**SUNDRY NOTICES AND REPORTS ON WELLS**  
*Do not use this form for proposals to drill or to re-enter an abandoned well. Use form 3160-3 (APD) for such proposals.*

8. Well Name and No.  
EE FEDERAL 24 3

9. API Well No.  
30-015-34213-00-S1

## EE Federal #3 Plug and Abandon Procedure

**EE 24 Federal #3  
Proposed WB**

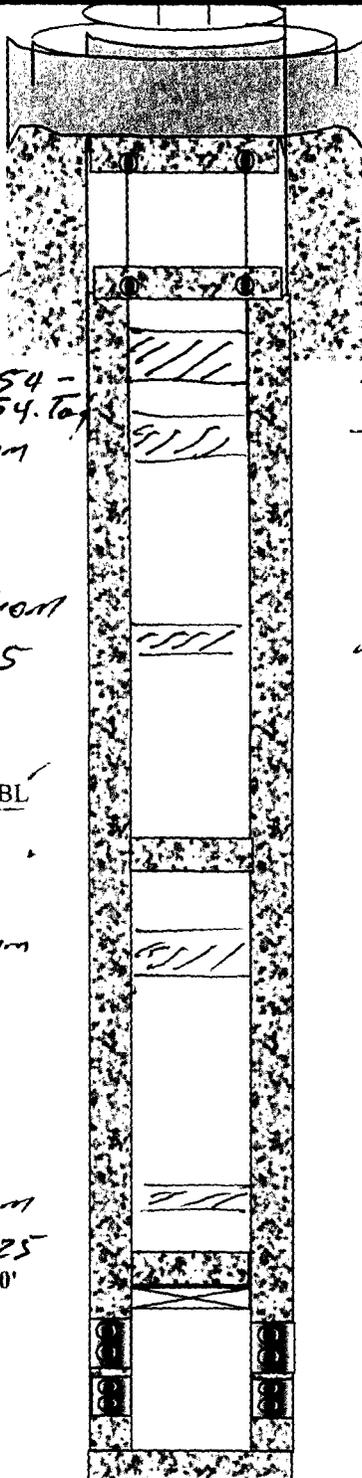
*Spot plug - shoe from 1254 - 1154. Top*  
*Add Glorietta 120' from 1970 - 1850*

*Add Yeso 130' min from 2785 - 2655*

Spot 25 sxs. 3710' - 3610' *146'*

*Add Abo 140' plug from 4070 - 3930*

Spot 25 sxs. 5350' - 5250' *150'*

*Add Cisco 170' plug from 6695 - 6525*

San Andres *273' 450'*

Canyon: *7500'*  
7,678' -7,863'

*Add Plugs - Cisco, 170' 25 sx min From 6695 - 6525.  
ABC, 140' 25 sx min From 4070 - 3930  
Yeso, 130' 25 sx min From 2785 - 2655  
Glorieta, 120' 25 sx min From 1970 - 1850  
Shoe plug From 1254 - 1154 25 sx min, Tag.*
